SAFETY RECALL RVXX0702 AUGUST 2007

SAFETY RECALL BULLETIN

SUBJECT: Steering Shaft Lock Nut

Typical VN-2, VHD-2 and VT steering shaft

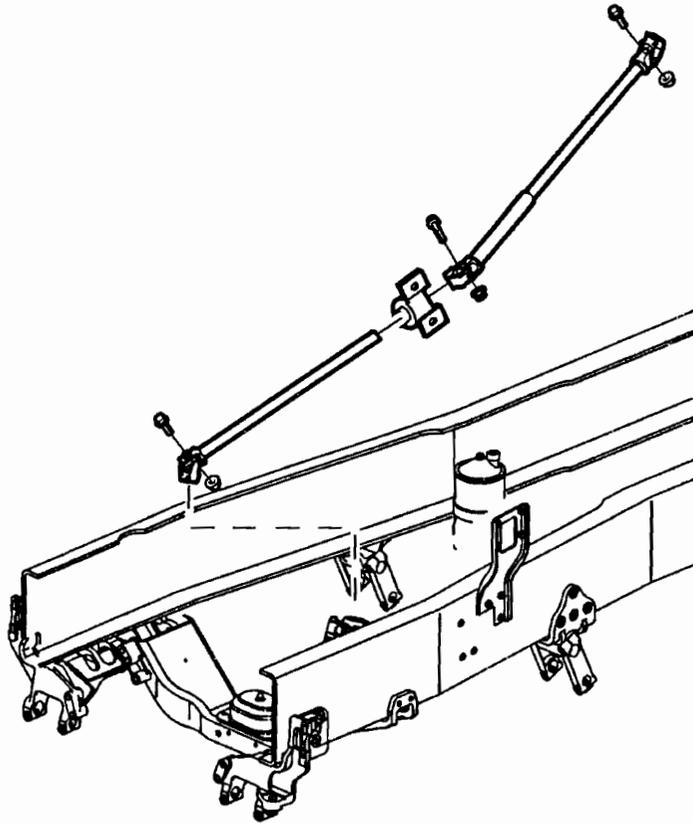
5. Remove the pinch bolt from the gear end of the steering shaft.
Note: On VHD axle forward models there will be an additional pinch bolt to replace at the shaft support bearing.

On VN-2 VHD-2 and VT models install the new pinch bolt (20924949) and nut (971086).
Tighten the pinch bolt to 60 ± 10 Nm (45 ± 7 ft-lb).

VHDF-2 Steering Shaft

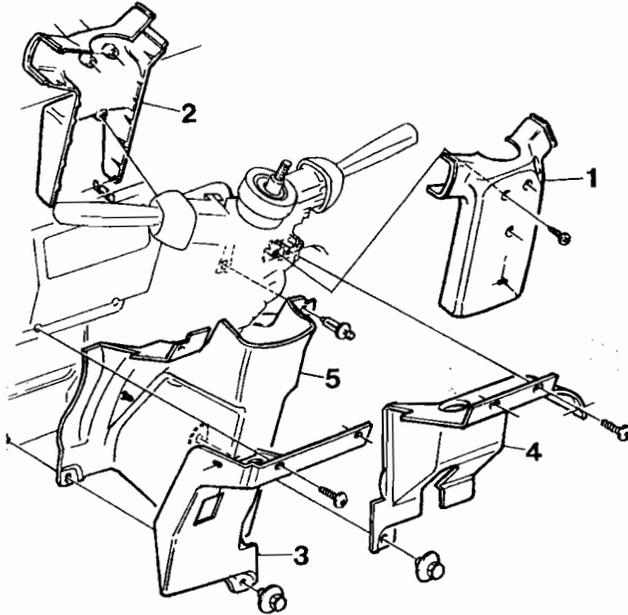
On VHDF-2 models install the new pinch bolts 20924949) and nut (971086) one at the steering gear and one at the support bearing. Tighten the pinch bolts to 60 ± 10 Nm (45 ± 7 ft-lb).
